RE: **Lot 1 Block 9 SAD 228**
6601 Petirrojo NW
Volcano Cliffs Subdivision
Grading and Drainage Plan
Engineers Stamp Date 5/30/19 (D10D003I1)

RE: Hydrology File # D10D00311, 6601 Petirrojo NW

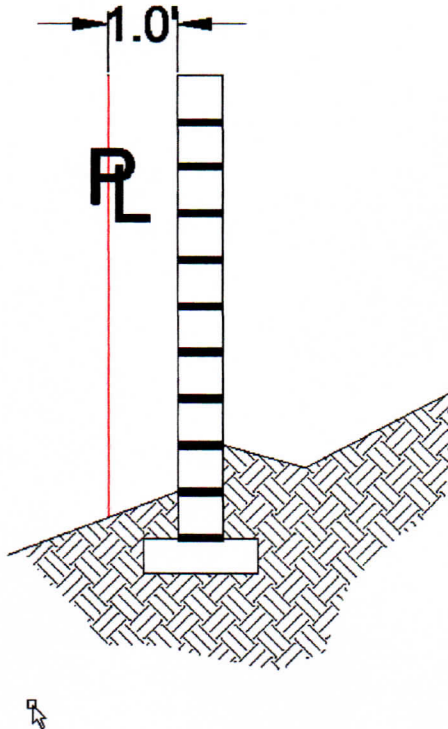
Dear Mr. Hughes,
Here is the cross section of the proposed garden wall that you requested for this property in your comment letter dated June 11, 2019.
